## **CASE OFFICER'S REPORT**

**17/05957/FUL/FUL Demolition and replacement of the single family dwelling.  
Knighton Mill, Knighton Road, Broad Chalke, SP5 5DX.**

Estimated lines of view from proposed south elevation .....and west elevation

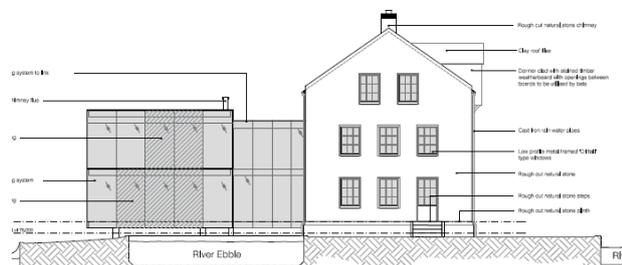
The occupiers of Hatchfield House would be more aware of the south elevation of the replacement dwelling on the approach to their property along the access, as it is taller than the existing mill and orientated towards the approach. However, the new south elevation would be orientated away from Hatchfield House and its gardens, looking south along the access towards the agricultural buildings at the road junction and would not appear to result in any *direct* overlooking.

The occupiers of Hatchfield House have said, *Finally we are concerned that the height of the new house will affect our privacy in our garden / swimming pool area. Currently we are not overlooked by the existing house. This is a comment rather than objection but we would like our concern for long term privacy noted.*

Therefore, a condition would be placed on any permission to ensure that no new windows, dormers or rooflights are added to the west elevation of the development in future. Furthermore, the existing important tree and shrub cover on the west boundary is shown to be retained and reinforced on the landscape plan:
